CHANGE }
No. 1 }

HEADQUARTERS
DEPARTMENT OF THE ARMY
WASHINGTON, DC, 8 January 1982

**Organizational Maintenance Manual
CRANE-SHOVEL, TRUCK MOUNTED; 3/4 CUBIC YARD;
20 TON; WITH CLAMSHELL, DRAGLINE, AND BACKHOE
ATTACHMENTS; G.E.D. (HARNISCHFEGER CORP MODEL M320T2)
NSN 3810-00-151-4431**

TM 5-3810-294-20, 5 April 1974, is changed as follows:

Figure 2-105.1. Adjusting front and rear drum brakes.

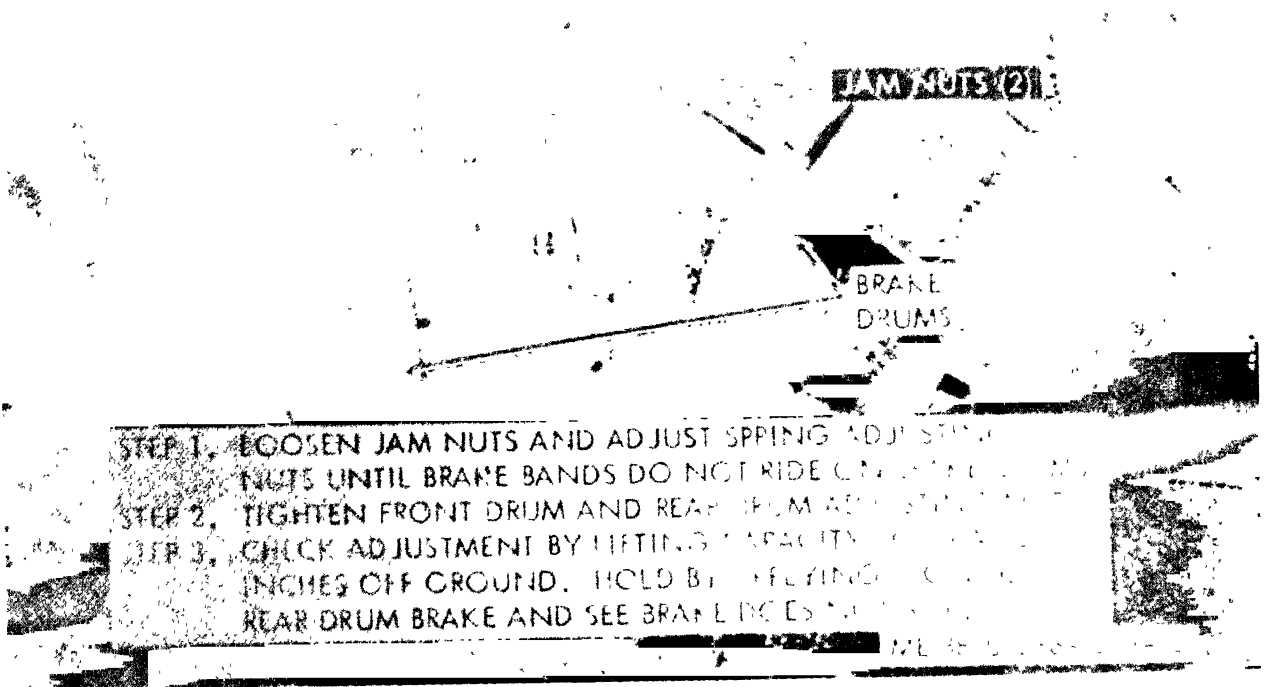
Figures 2-105.1 and 2-105.2 are added as follows.
